**VALUE ENGINEERING STUDY
OF
I-85 FROM HAMILTON MILL ROAD, GWINNETT COUNTY
TO THE SOUTH CAROLINA STATE LINE
PROJECT NO. NH-IM-85-2(165-175)**

FEBRUARY 28 – MARCH 02, 2005

**Prepared by:
Ventry Engineering, L.L.C.**

**In Association With:
GEORGIA DEPARTMENT OF TRANSPORTATION**

AS PROPOSED TYPICAL SECTION

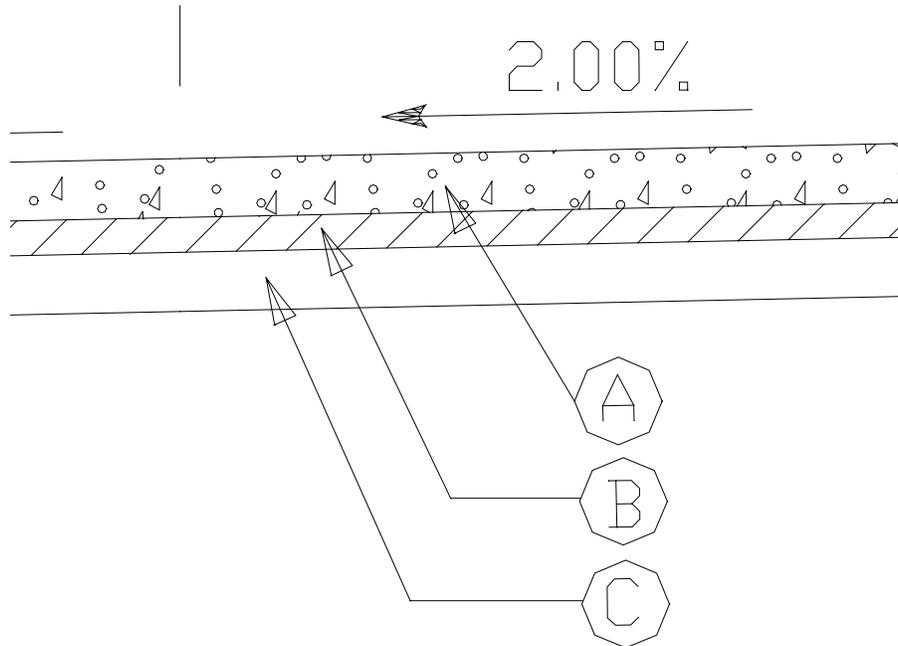
The 10 projects included in this Value Engineering Study widen Interstate 85 from near Hamilton Mill Road to the South Carolina line. The existing roadway consists of two 12-foot lanes in each direction with 4-foot inside and 10-foot outside paved shoulders. The original construction of the Interstate some 40 years ago was non-doweled jointed concrete paving for the travel lanes. Several overlays have occurred since its original construction and the asphalt depth is estimated to be 7-10 inches. There is a short section of about 4 miles in Banks County that is still the original concrete paving.

Cross slope of the existing roadway is $1/8^{\text{th}}$ inch per foot. To obtain a corrected cross slope of $1/4$ inch per foot, the existing HMA overlay will be milled prior to the overlay. In the 4-mile PCC section in Banks County the projects add a 3 to 6 inch thick interlayer to correct cross slope, minimize reflective cracking and reduce infiltration of water.

The proposed project is to widen this 51.3 mile section to three lanes in each direction with adequate widening included to easily add a fourth lane in the future. The widening is mostly to the inside, but a portion of the existing outside shoulder is also replaced full-depth. The pavement section of the inside shoulder, lane 1 and half of lane 2 is 12-inches of graded aggregate base, topped by three inches of 19mm Superpave HMA, topped by 11" of CRC. The pavement section of half of lane 2, lane 3 and most of the 14 foot wide outside shoulder (future lane 4) incorporates the existing pavement structure. Under this concept 11" of CRC pavement and a 3-6 inch thick HMA interlayer is either added in Banks County or milled into the existing HMA overlay everywhere else.

Value Engineering Alternative No. 1 Typical Section

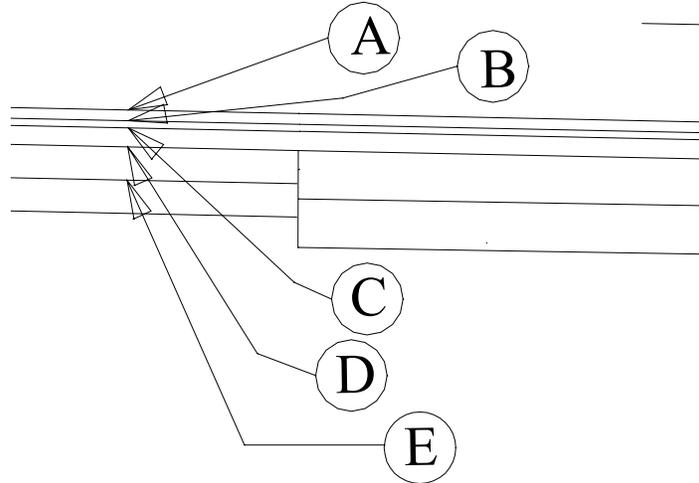
Value Engineering Alternative No. 1 to the proposed concrete overlay is to use asphalt paving for the widening and overlay of the existing roadway.

Similar to the As Proposed, the new roadway would have to be constructed in stages. The first stage will be construction of a new HMA roadway in the median area. This pavement structure includes 12” of graded aggregate base, 7” of 25 MM Superpave, 4” of 19 MM Superpave, 1 ½” of SMA, and 2 ¼” of PEM. This stage will also provide a rigid barrier along 45 of 51 miles of the corridor.

In the second stage, traffic will be shifted to this new roadway and separated by a temporary concrete barrier from the existing pavement. The existing roadway will be milled at variable depths to obtain a proper cross slope and overlaid with asphalt. This overlay will consist of 4” of 19 MM Superpave, 1 ½” of SMA and 2 ¼” of PEM. Eight feet of the outside shoulder will be reconstructed along the entire corridor which will require 12” of GAB and 7” of 25MM Superpave in addition to the 4” of 19 MM Superpave, 1 ½” of SMA and 2 ¼” of PEM. The widening in this stage will be of sufficient width to accommodate the 12-foot shoulder, which is the future fourth lane. The Value Engineering Team calculated a sufficient quantity of PEM to provide an 18” lap on the inside and outside shoulders through the entire corridor. A Typical Section follows to detail the Value Engineering Alternative.

The cost for using asphalt to accomplish the proposed widening is estimated to be \$132,007,000. With the additions of inflation for 3 years and a contingency of 10%, the estimated cost savings is \$225,437,000.

VALUE ENGINEERING ALTERNATIVE NO. 2 TYPICAL SECTION

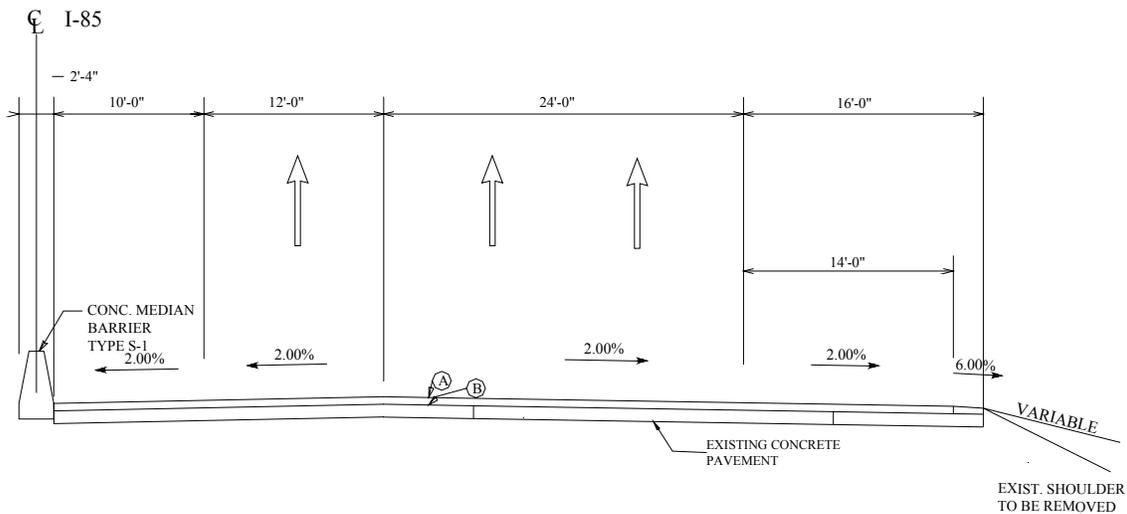
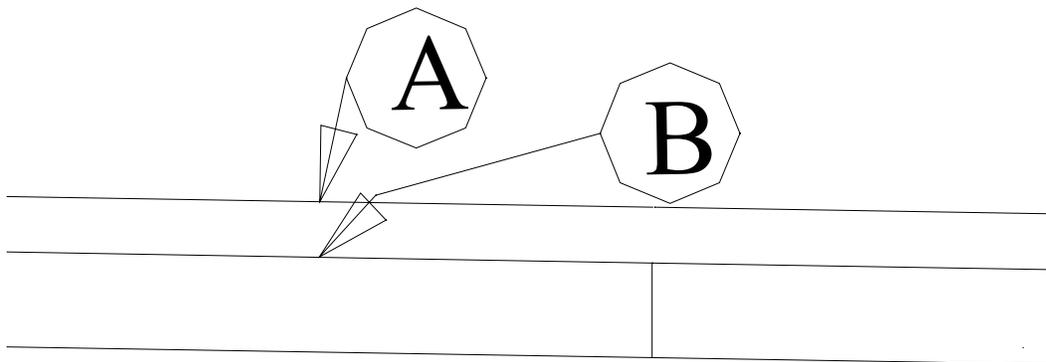
This Value Engineering Alternative to the proposed concrete overlay is to use a bonded overlay of PCC over the existing PCC pavement with RCC as the base course for the new lanes in the median.

Similar to the As Proposed, the widening will have to be constructed in stages. The first stage will be construction of a new PCC roadway in the median area. This pavement structure includes 8" of RCC with a 6" overlay of PCC. This construction method should require fewer steps and should reduce the time for construction. The RCC layer will use vibrated joints prior to the compaction stage to achieve high load transfer. Joints will be sawed in the PCC overlay directly over the RCC joints. Joint spacing will be based on joint spacing of the existing concrete, which should be visible along the edge. This stage will also provide a rigid barrier along 45 of 51 miles of the corridor.

In the second stage, traffic will be shifted to this new roadway and separated by a temporary concrete barrier from the existing pavement. The existing roadway will be milled to the original jointed non-doweled 8" concrete, which is estimated to be 7 - 10 inches beneath the current PGL. A variable depth bonded concrete overlay will then be placed on the original concrete. The bonded overlay depth will be 6 to 9 inches to provide the proper cross slope. The bond will be a mechanical one with the roughened concrete surface resulting from the milling. Eight feet of 8" thick RCC will be used to reconstruct the outside shoulder of the original pavement. The bonded overlay will cover 6 of the 8 feet of RCC placed on the outside shoulder. The widening in this stage will be of sufficient width to accommodate the 14-foot shoulder, which is the future fourth lane.

During the development of this alternative, an innovative method of treating the transverse joint was recommended. At the transverse joint a section of the old slab will be removed. This section will be 24" wide at the bottom and 30" wide at the top. One and a half inch dowel bars will be placed in the center of the proposed overlay. This new "notch" will be poured monolithically with the overlay. (See the detail below.) The cost for the dowel bars and the additional concrete required was included in the cost development.

The cost for using bonded PCC overlay to accomplish the proposed widening is estimated to be \$191,300,000. With the additions of inflation for 3 years and a contingency of 10%, the estimated cost savings is \$135,400,000.

1. AS PROPOSED

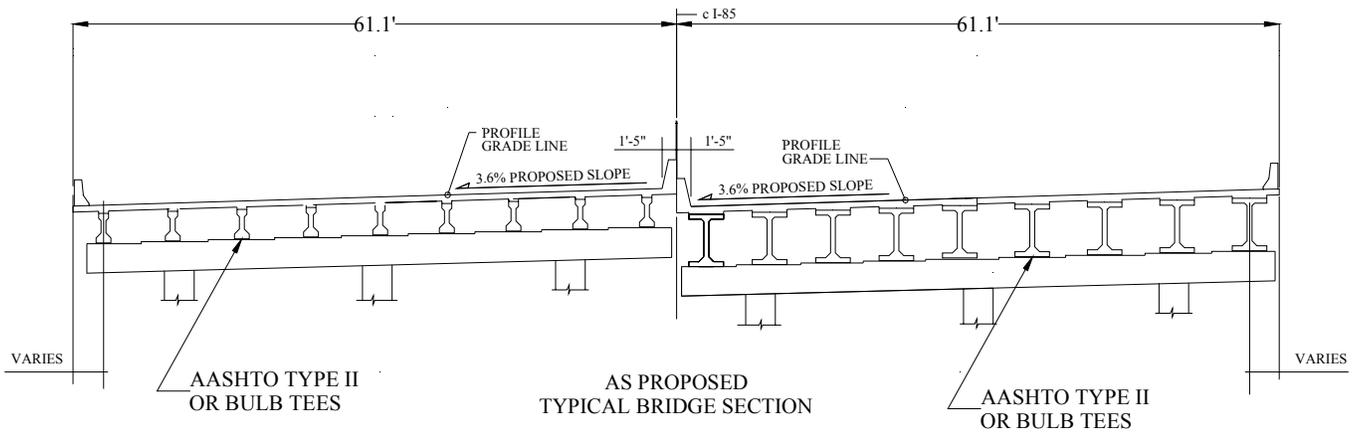
The As Proposed design consists of removal of the existing 4 span, steel beam, and dual bridges over Mulberry River and construction of a new bridge. The existing dual bridges are 228 ft. in length and 45 ft. wide. The Sufficiency Rating of these bridges is 95.4. The new bridge will be 223 ft. in length and 122 ft. wide. The new bridge is a 3 span structure with span lengths of 54 ft., 115 ft., and 54 ft. The end spans are AASHTO Type II PSC beams while the center span is made up of Bulb Tee PSC beams.

2. VALUE ENGINEERING ALTERNATIVE

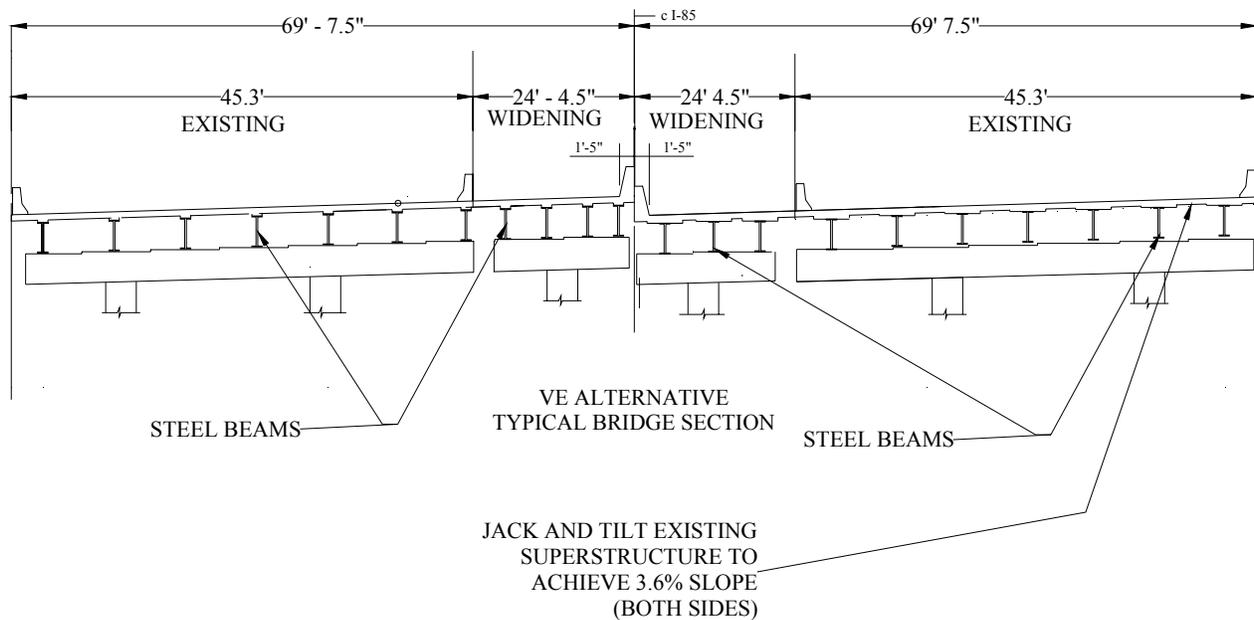
The Value Engineering Alternative consists of retaining the existing dual bridges and widening on the inside. The total widening will be about 49 ft. and including the existing bridges the overall width will be 139.5 ft. This is approximately 17 ft. wider than the As Proposed bridge replacement. In order to provide the cross slope of 3.6% the existing bridges will have to be jacked and tilted. The Georgia Department of Transportation has experience in this method of correcting cross slope on bridges. The widening will use steel beams to match the existing superstructure.

A Life Cycle Cost Analysis of the As Proposed new bridge with a 75-year life against the Value Engineering Alternative with a remaining life of 37 years shows that the Value Engineering Alternative is more economical by \$120,020.

1. AS PROPOSED

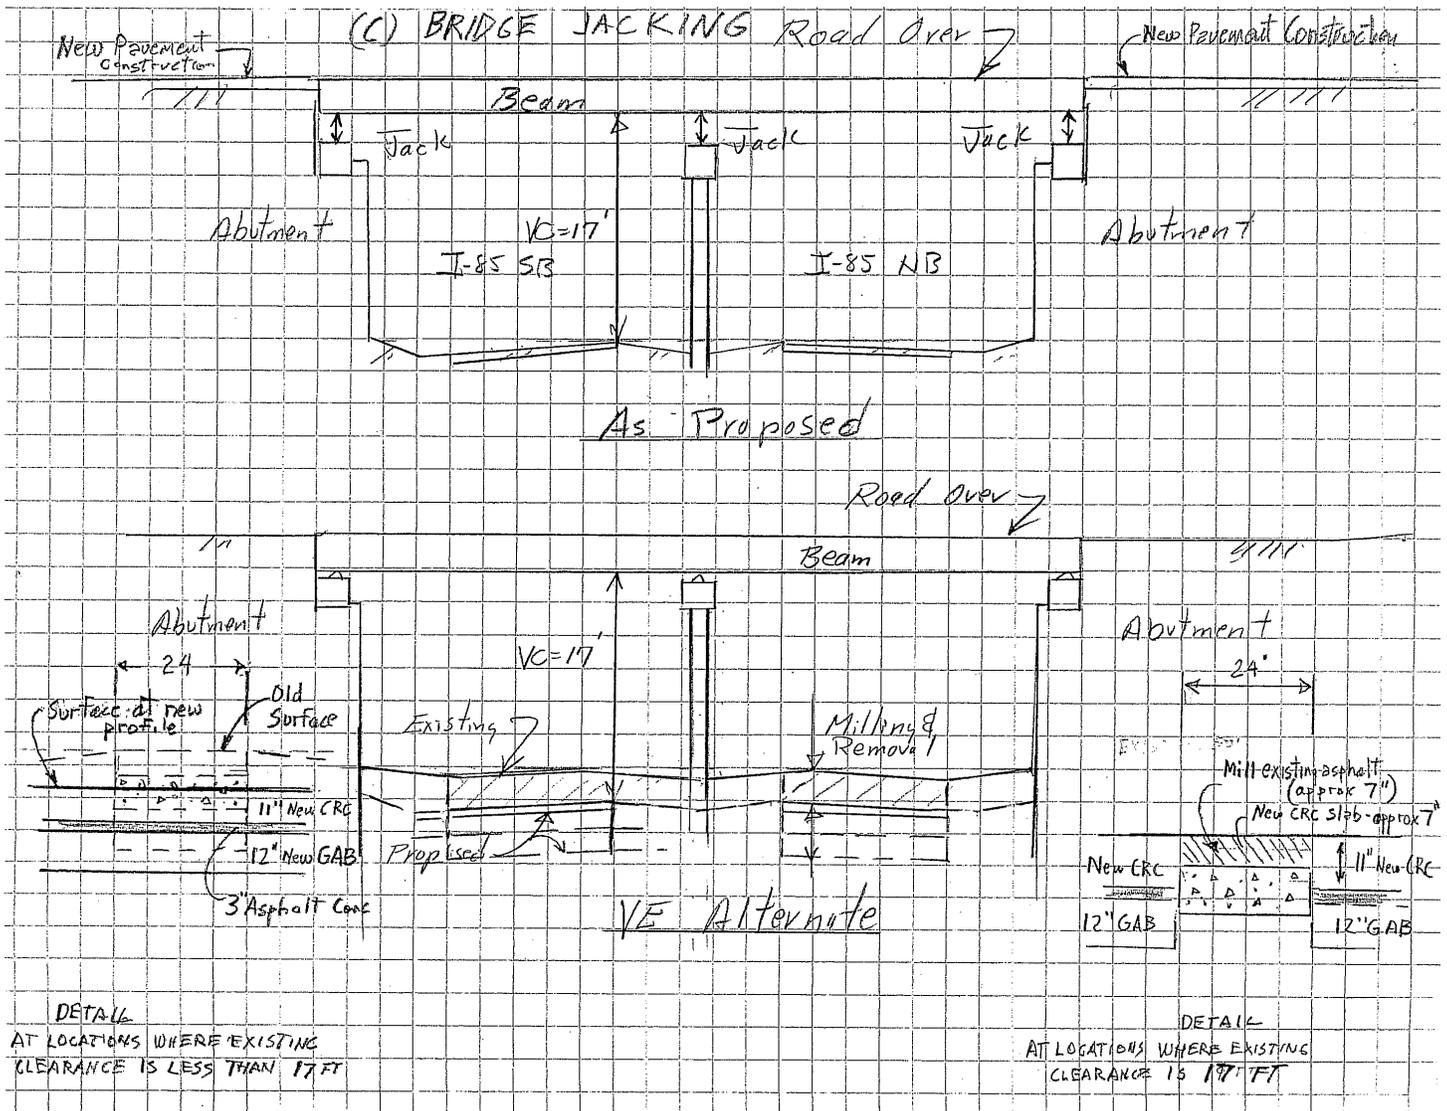
There are 15 known bridge sites on I-85 where either the vertical clearance is less than the desired 17 ft., or the 11-inch CRC pavement over the existing pavement would reduce the vertical clearance to less than 17 ft. The proposed solution to providing 17 ft. vertical clearance at all necessary locations is to jack each bridge. The jacking operation will be done over I-85 and therefore will require special protection to shield I-85 vehicles from any harm. In addition, the traffic using the cross roads may suffer delays or detours. The profile of the approach roadways will have to be adjusted upward, requiring new pavement construction for hundreds of feet north and south of the existing bridges.

2. VALUE ENGINEERING ALTERNATIVE NO. 1

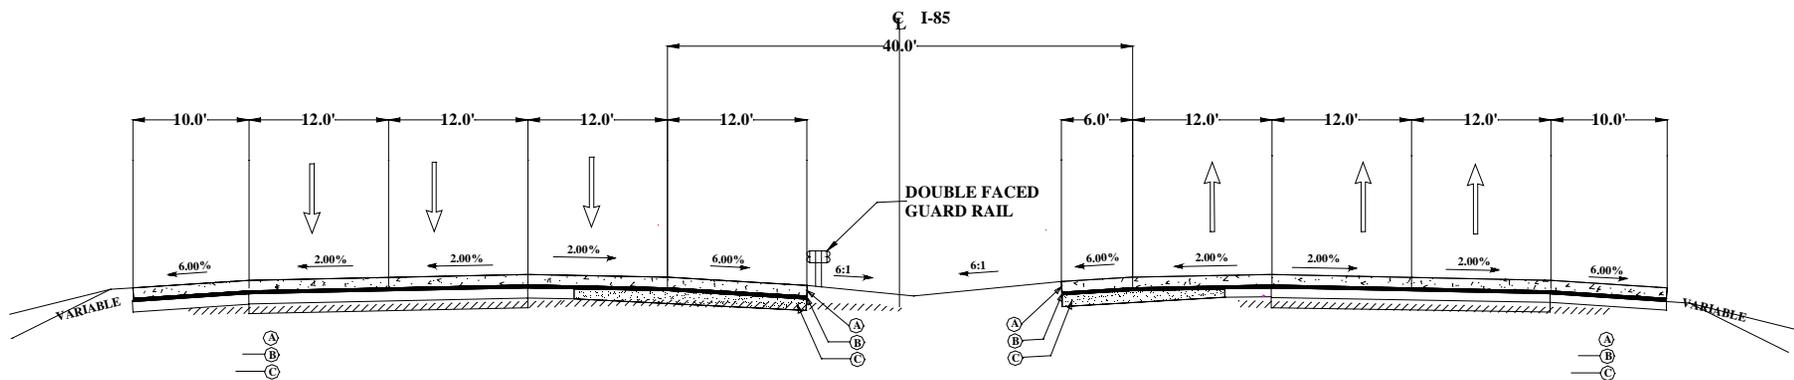
The Value Engineering Team recommends replacing the 2-ft. 4-inch wide Concrete Median Barrier (Type S-1) with double faced W – Beam guard rail that is offset 12 ft. from one of the inside travel lanes as shown on the following sheet. With the As Proposed Concrete Barrier System, both directions of travel have an obstacle (the barrier) within 10 ft. of the inside travel lane. The Value Engineering Alternative increases this obstacle distance to the travel lane to 12 ft. for one direction of travel and to 26 ft. +/- feet for the other resulting in a reduce risk for collisions with an obstacle.

1. Replacing a \$90/LF concrete barrier with a \$20/LF guardrail.
2. Greatly reduces the amount of the closed drainage system improvements required to remove storm water from the median.
- 3 . Reduces the amount of cross sectional pavement by 22 ft.

3. VALUE ENGINEERING ALTERNATIVE NO. 2

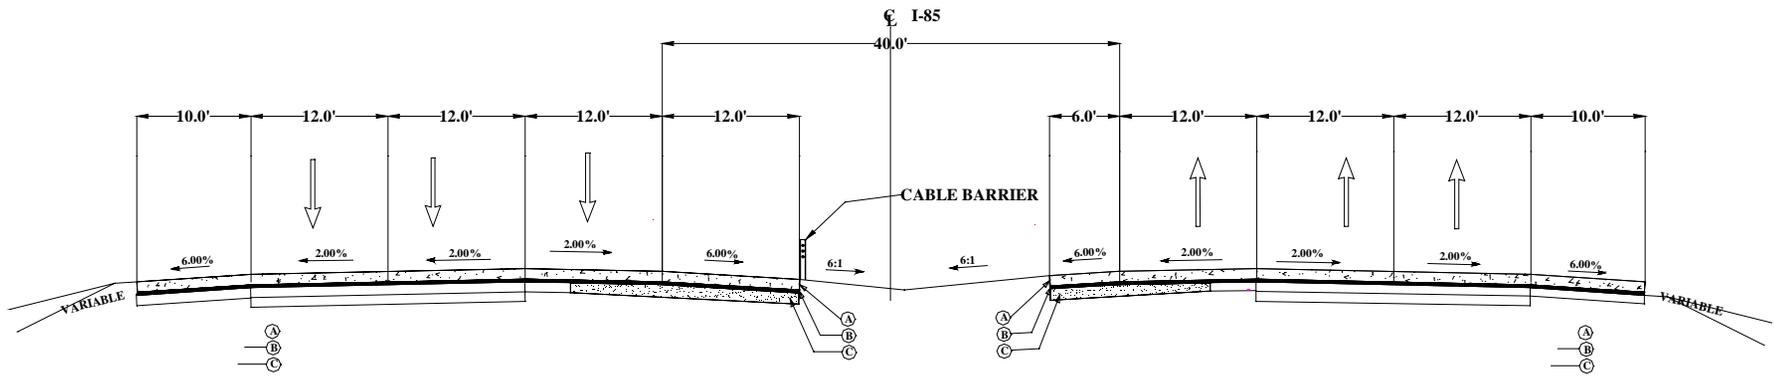
The Value Engineering Team recommends replacing the 2-ft. 4-inch wide Concrete Median Barrier (Type S-1) with a Cable Barrier System that is offset 12 ft. from one of the inside travel lanes as shown on the following sheet. With the As Proposed Concrete Barrier System, both directions of travel have an obstacle (the barrier) within 10 ft. of the inside travel lane. The Value Engineering Alternative increases this obstacle distance to the travel lane to 12 ft. for one direction of travel and to 26 ft. +/- feet for the other resulting in a reduce risk for collisions with an obstacle.

1. Replacing a \$90/LF concrete barrier with a \$20.50/LF Cable Barrier System.
2. Greatly reduces the amount of the closed drainage system improvements required to remove storm water from the median.
3. Reduces the amount of cross sectional pavement by 22 ft.

1. AS PROPOSED

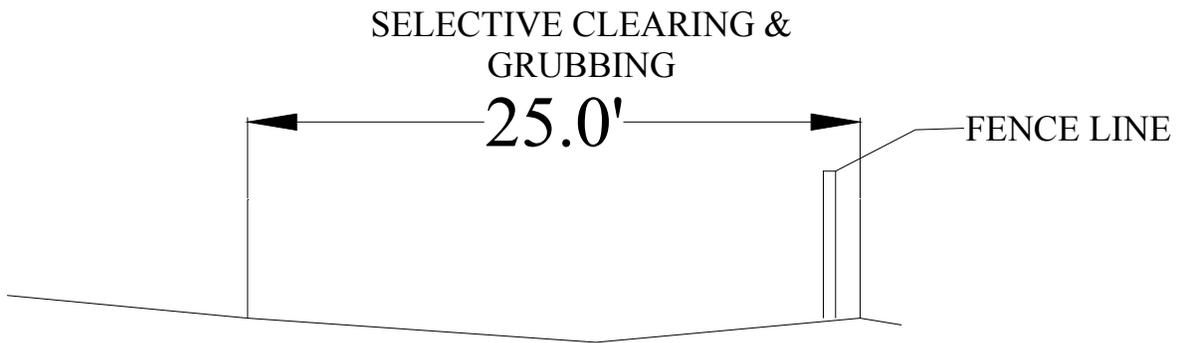
Replace Access Fence on both sides of the 51 +/- mile project. Replacing the fence will have to include Selective Clearing & Grubbing to provide an adequate work space for the fencing contractor.

The Value Engineering Team recommends replacing only access fence that is damaged or past its useful life (estimated to be 10%).

1. AS PROPOSED

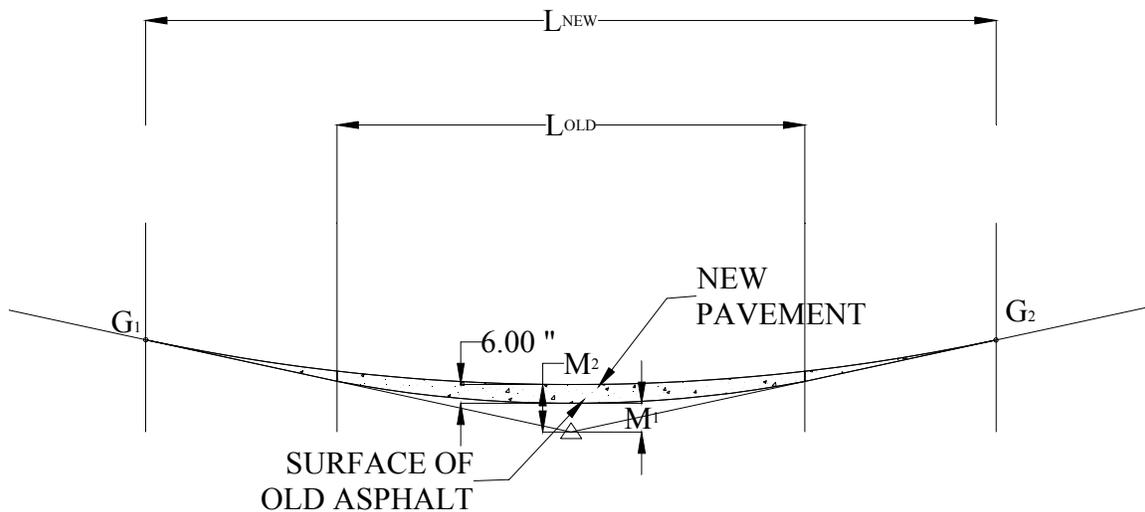
Adjust the Profile at Substandard Vertical Curves by filling in a lens of Asphalt Concrete of variable depth over existing four lanes of pavement for the complete length of the new sag vertical curve.

The example below shows a sample where the proposed sag vertical curve with a K value of 181 (70 MPH) is to be superimposed upon an existing vertical curve with a K value of 140, and the result is that there is a 6-inch rise in the new profile at the sag which coincides with an assumed 6-inch thickness of existing asphalt above the existing concrete slab built in 1963. For the computation, the existing K = 140 VC length is 430 ft., and the upgraded K = 181 VC length is 550 ft.

The As Proposed profile will require raising the pavement at the VPI at approximately thirty locations, and the amount to be filled varies from as little as 3 inches to as much as 2.97 ft. However, it is assumed that the difference in the materials used at each location will be virtually the same regardless of the overall depth of filling over the sag which is in excess of the 6 inches assumed to be available for milling.

2. VALUE ENGINEERING ALTERNATIVE

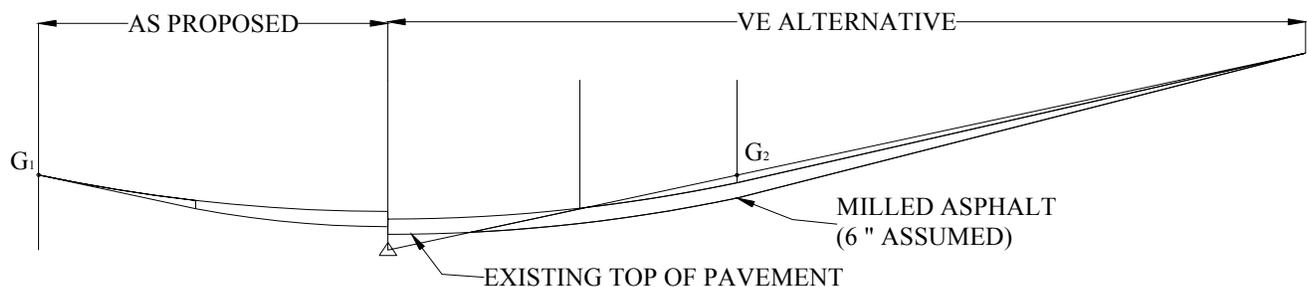
Mill the existing Asphalt Concrete in the vicinity of the beginning and the end of the new longer vertical curves to lay bare the old concrete slab, in order to minimize the depth of new asphalt concrete over the middle of the vertical curve at the PVI and low point.

It is assumed that there is a depth of approximately six inches of old Asphalt Concrete over the old Portland Cement concrete slab.

The majority of the approximately thirty substandard sag vertical curve locations require an asphalt concrete overlay which exceeds six inches at the point of maximum overlay (the PVI or the low point). Some of those locations need as much as two feet of asphalt concrete overlay. Nevertheless, all of the locations may benefit by milling whatever thickness of existing asphalt concrete overlay is available at any given substandard vertical curve location.
